ADDENDUM NO. 1

Date: **February 9, 2024**
Issued by: **Sacramento City Unified School District**
Project: **Project #0410-409-1 Albert Einstein MS Modernization**

PLUMBING ENLARGED GIRLS LOCKER ROOM DEMOLITION PLAN
 SCALE : 1/4" = 1'-0"

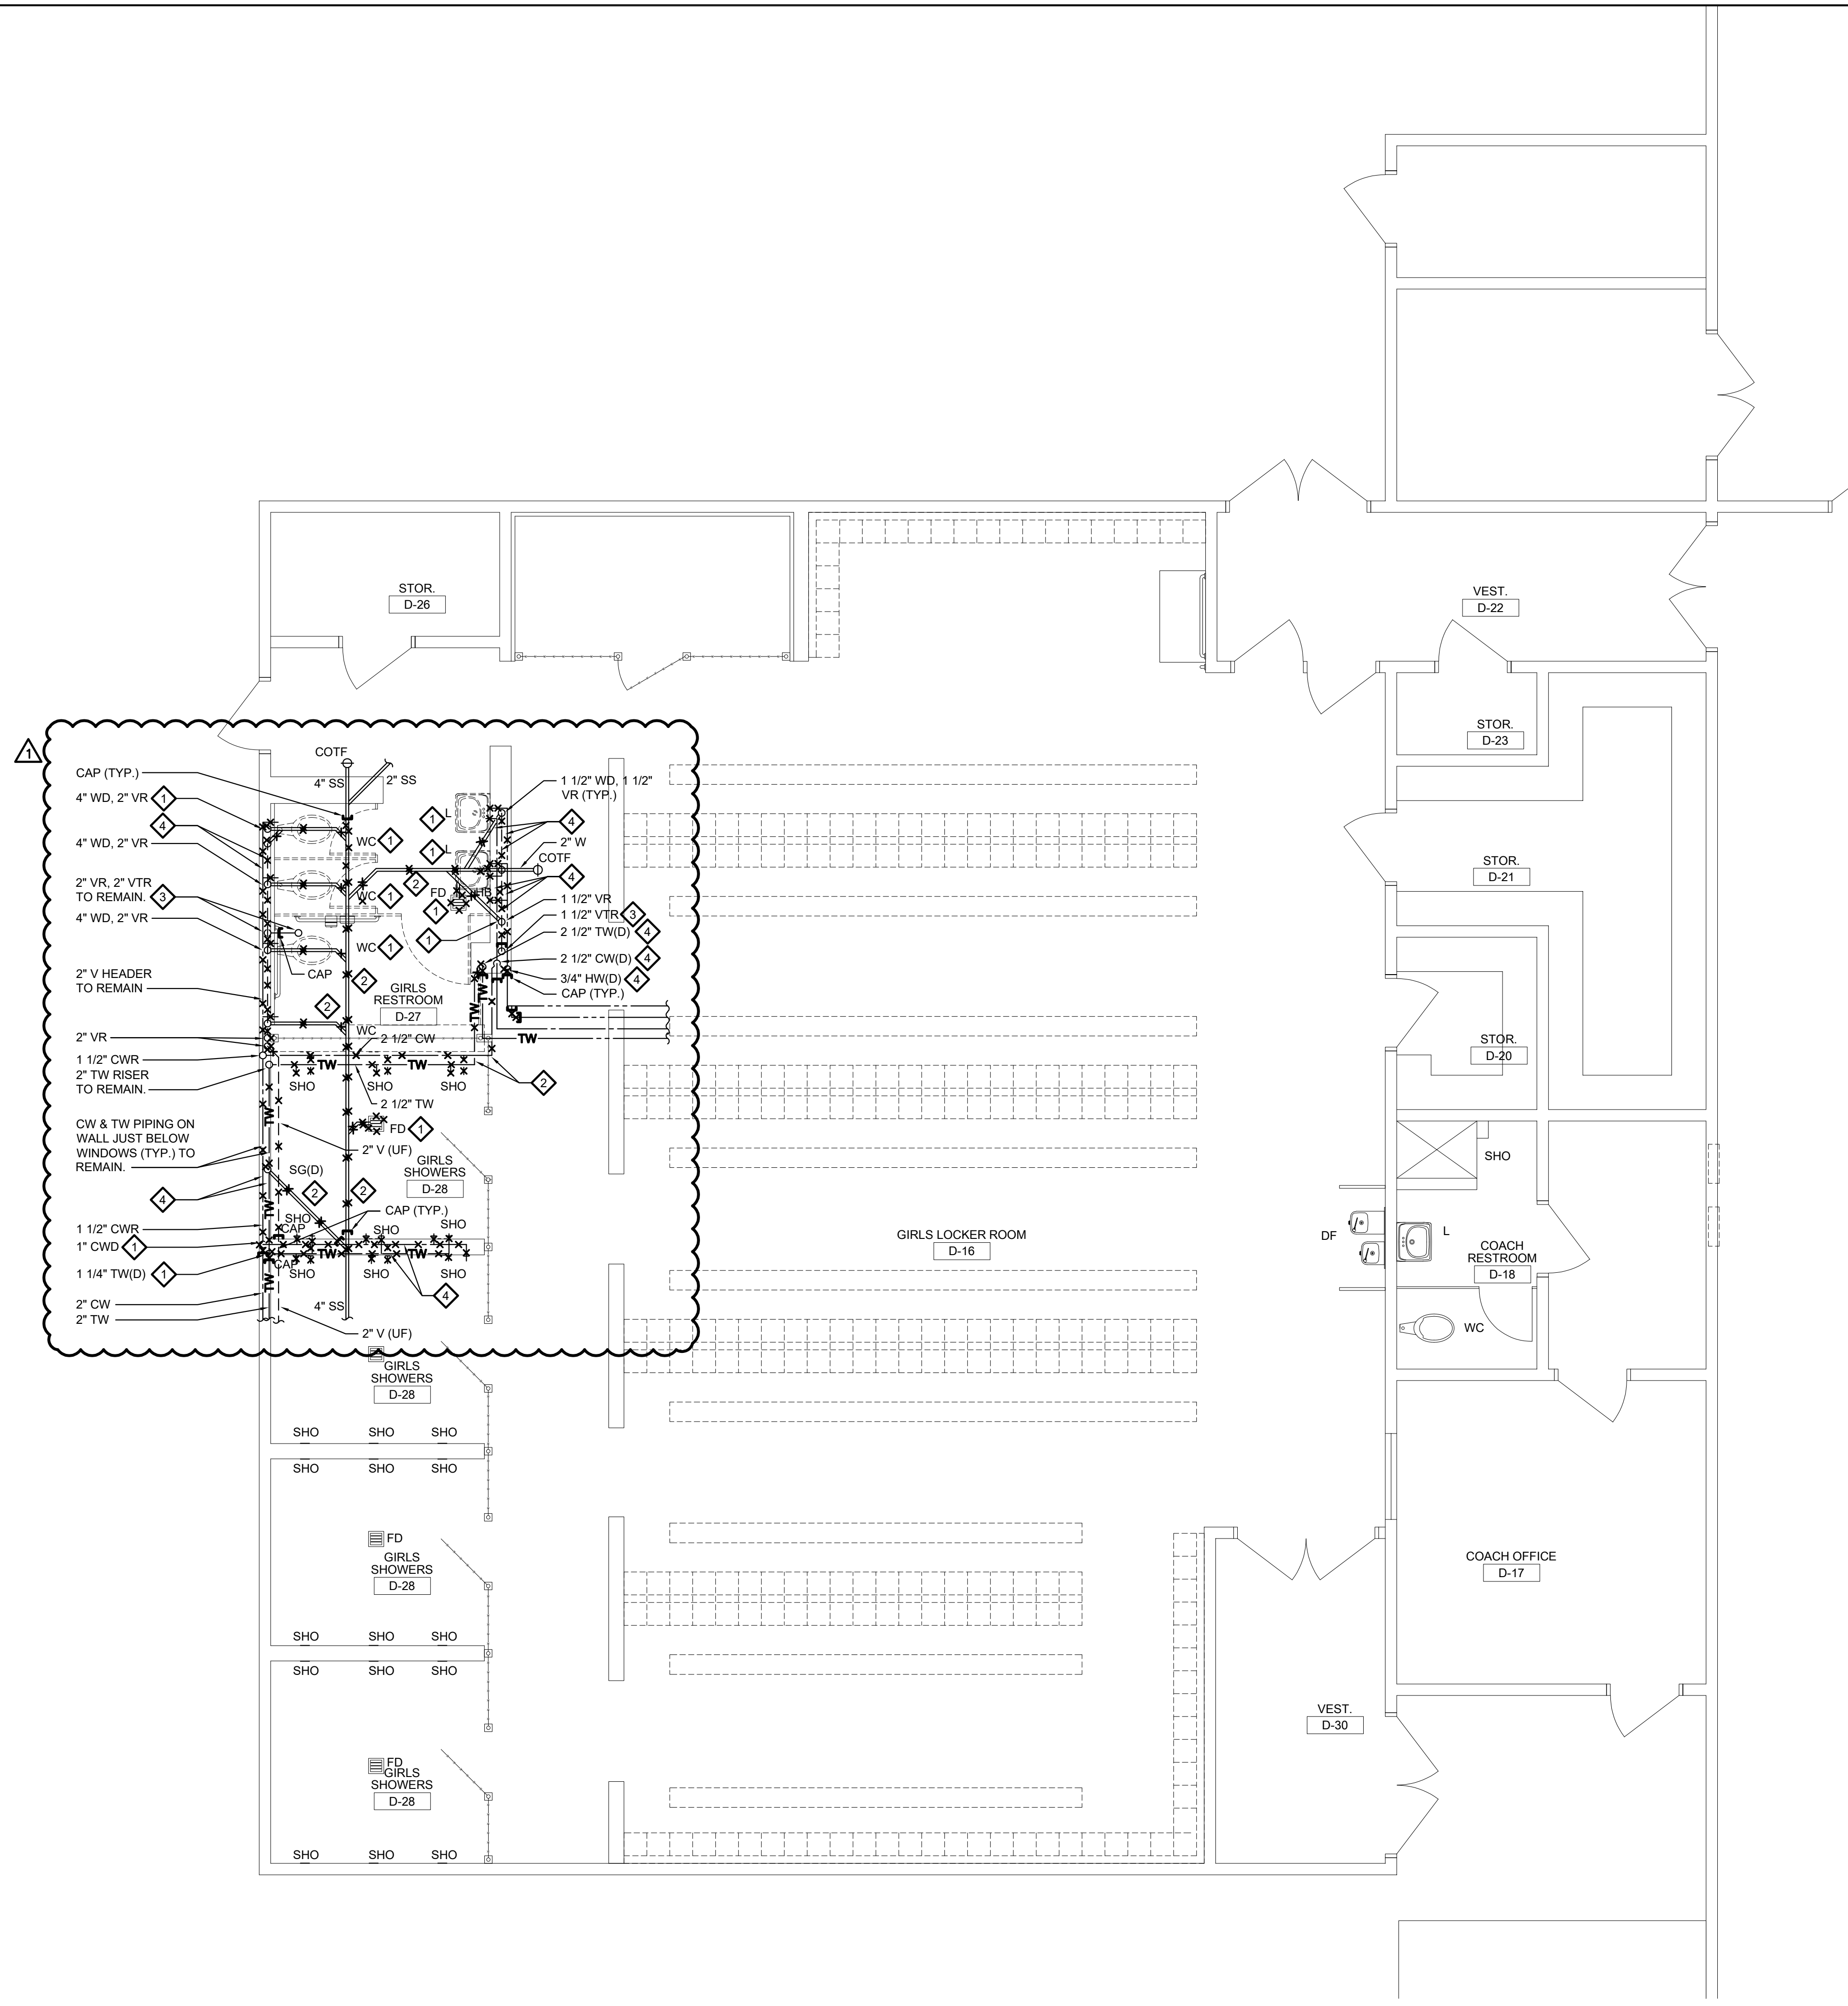
Addendum Item No. AD1.21 - P420 Plumbing Enlarged Girls Locker Room Demolition Plan (Package A)

- Replace sheet in its entirety per addendum drawing number AD01.21. Revised amount of piping demolition shown.

PLUMBING ENLARGED BOYS LOCKER ROOM DEMOLITION PLAN
 SCALE : 1/4" = 1'-0"

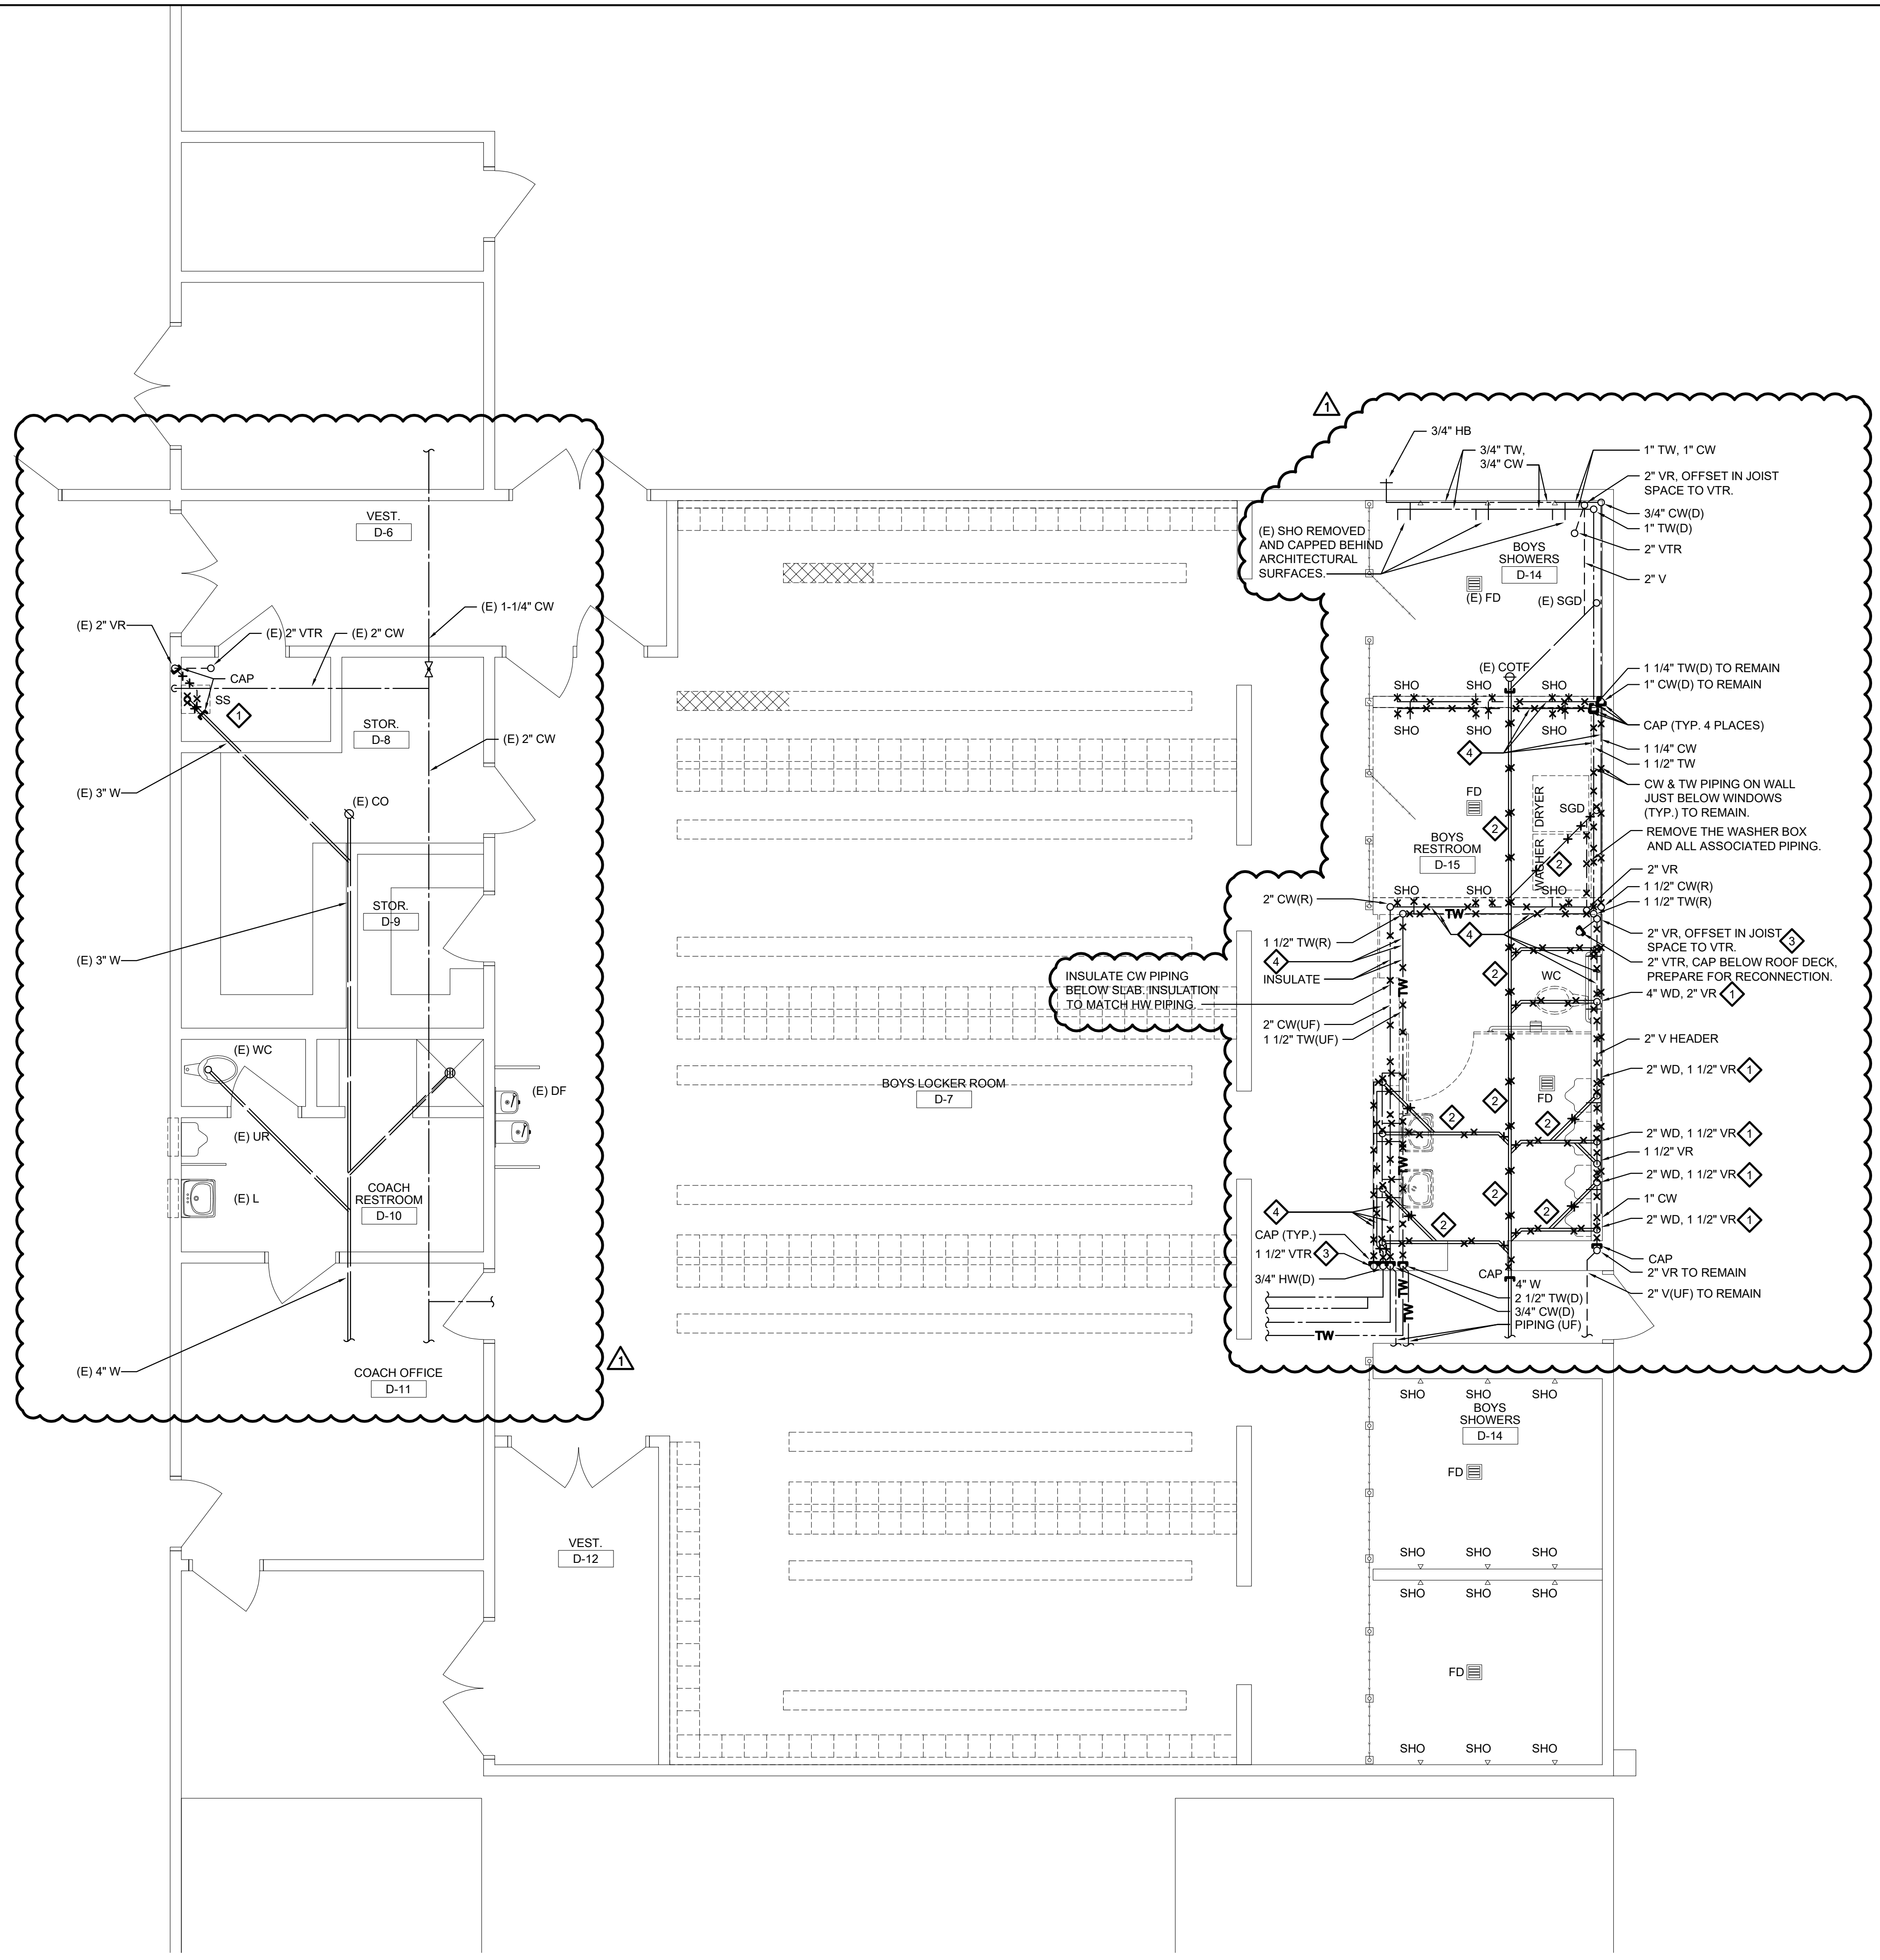
Addendum Item No. AD1.22 - P421 Plumbing Enlarged Boys Locker Room Demolition Plan (Package A)

- Replace sheet in its entirety per addendum drawing number AD01.22. Revised amount of piping demolition shown.

Q#7: Bid Package A – Sheet P421 – P421 does not provide sheet note tags in Boys Restroom denoting what is to be demoed.

Q#10: Bid Package A – Sheet P421 – P421 Note No. 7 states to delete and cap plumbing behind wall.
R#10: *Per discussion with CECI – See updated plans AD01.22 for piping in this area.*

R#7: *Per discussion with CECI – See updated plans AD01.22 for piping in this area.*

PLUMBING ENLARGED GIRLS LOCKER ROOM ALTERATION PLAN

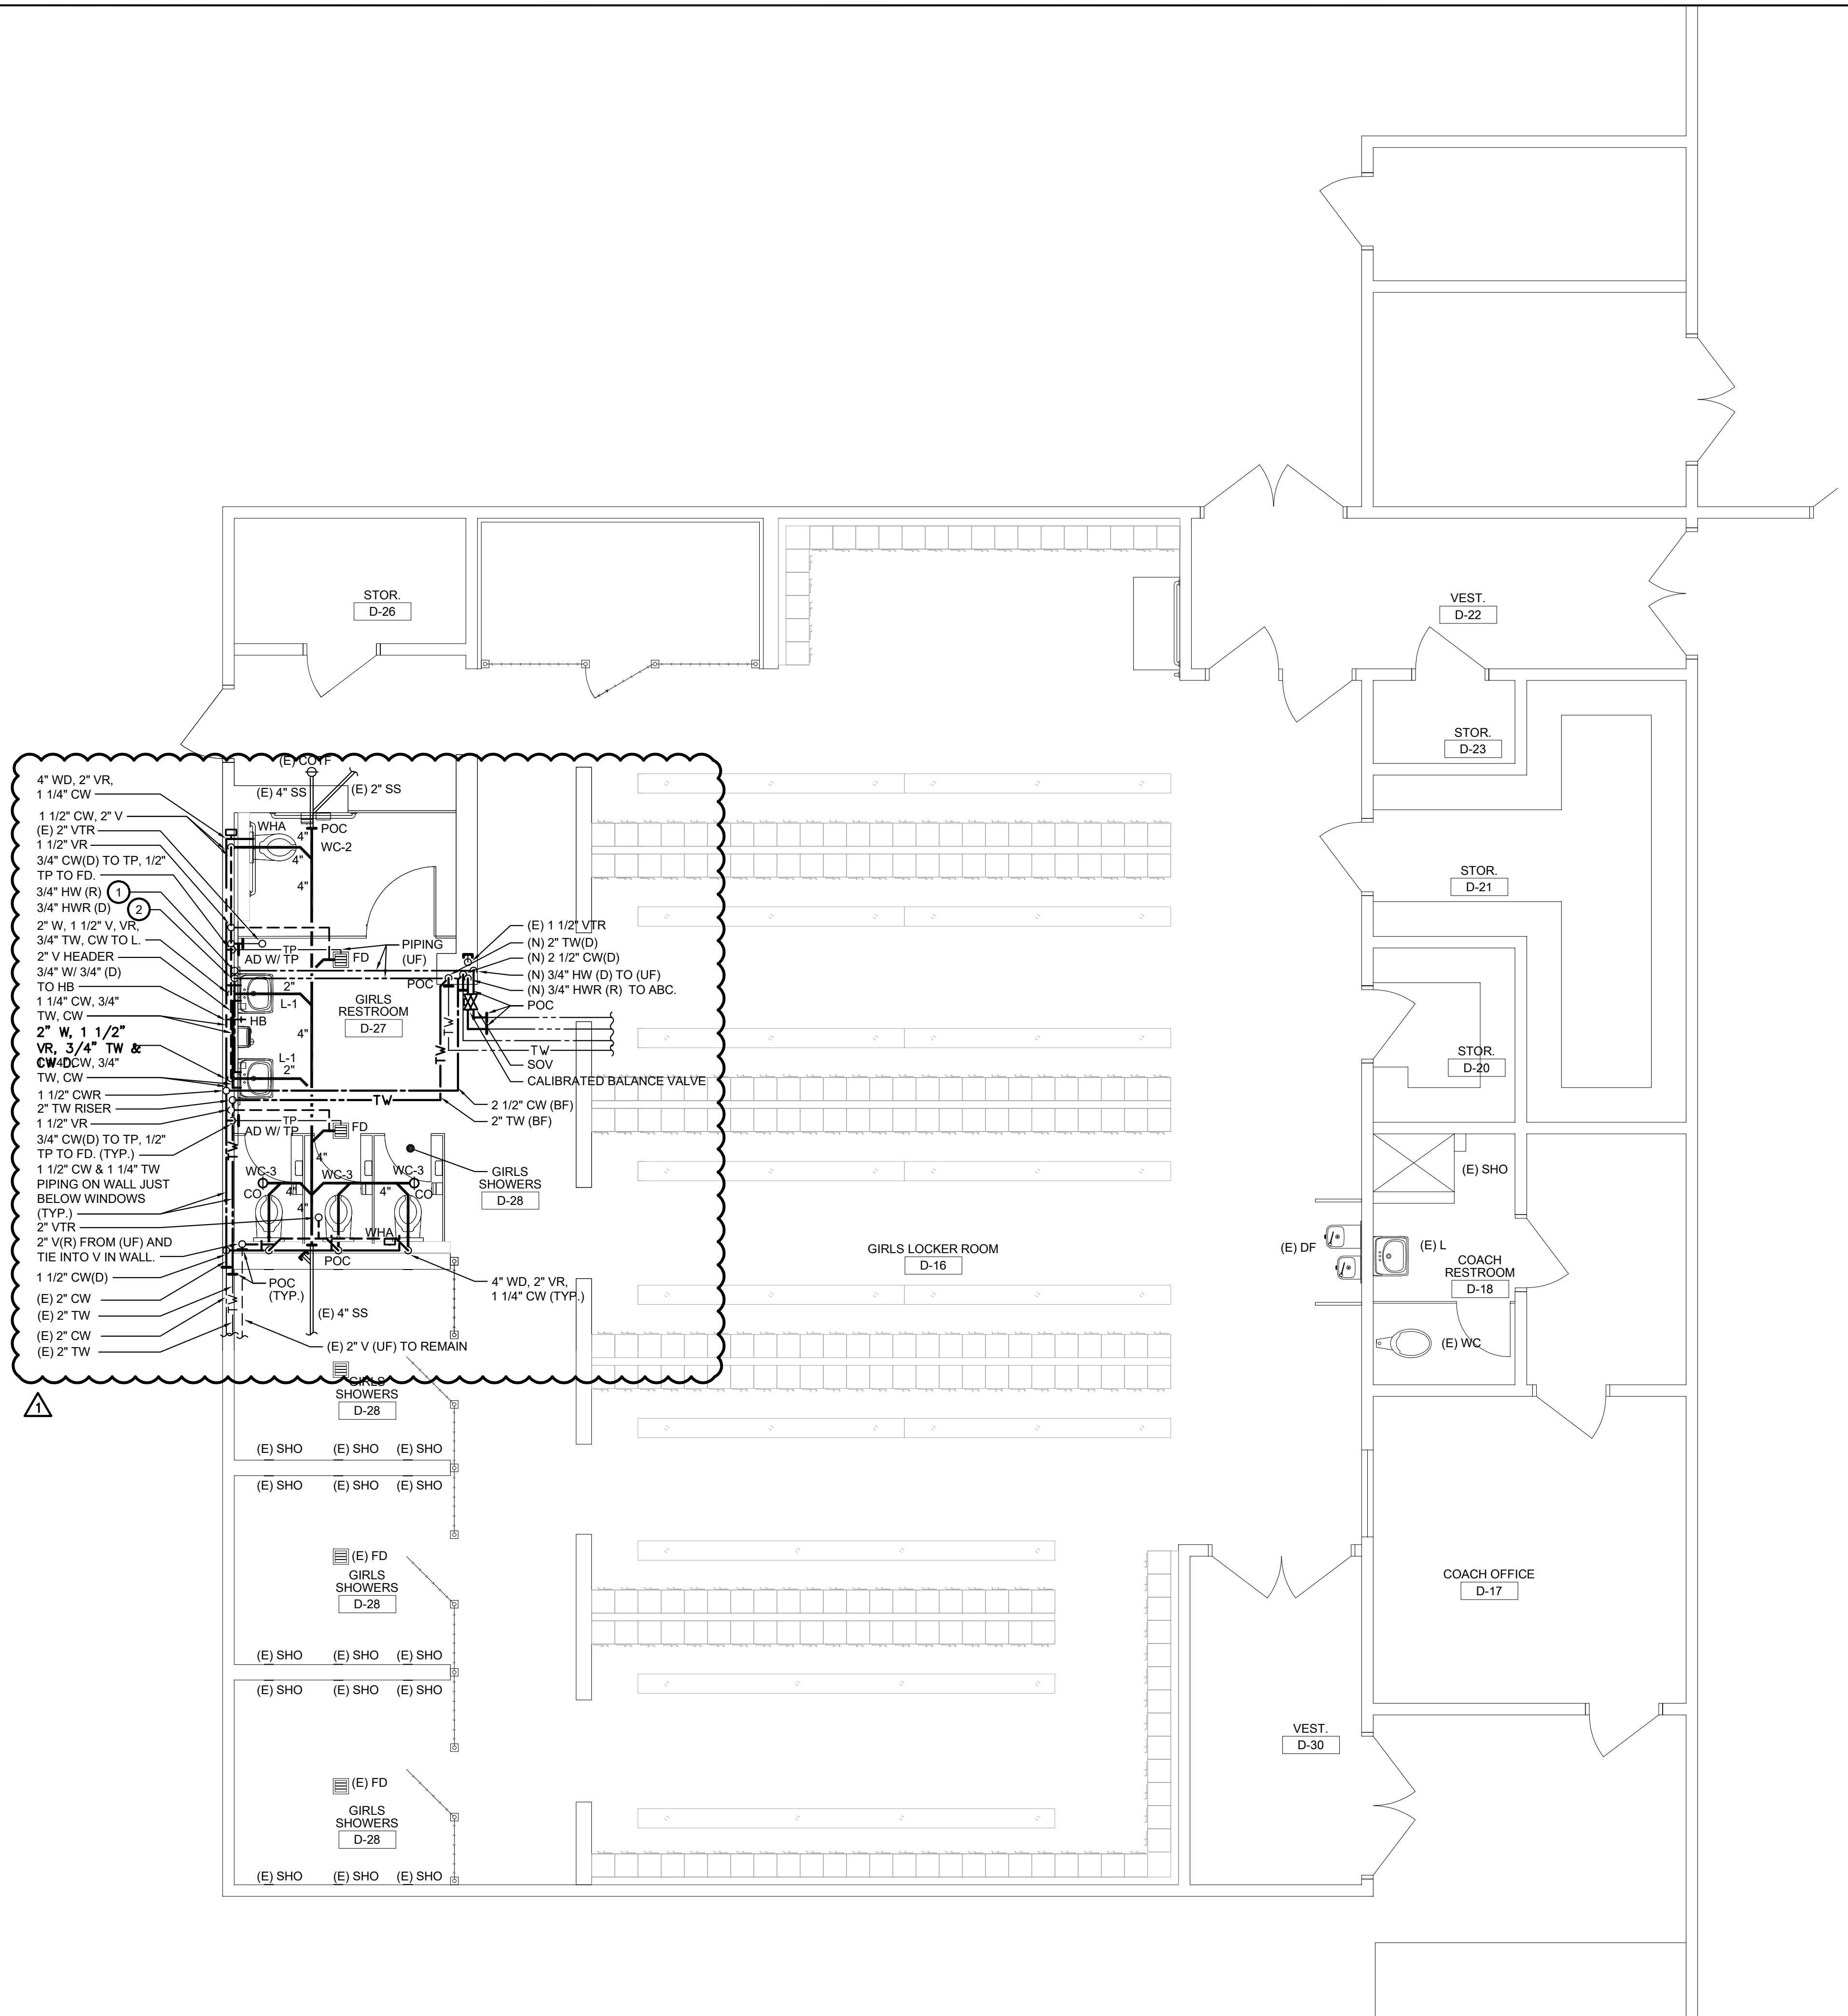
Addendum Item No. AD1.23 - P422 Plumbing Enlarged Girls Locker Room Alteration Plan (Package A)

- Replace sheet in its entirety per addendum drawing number AD01.23. Revised amount of new piping and routing as shown.
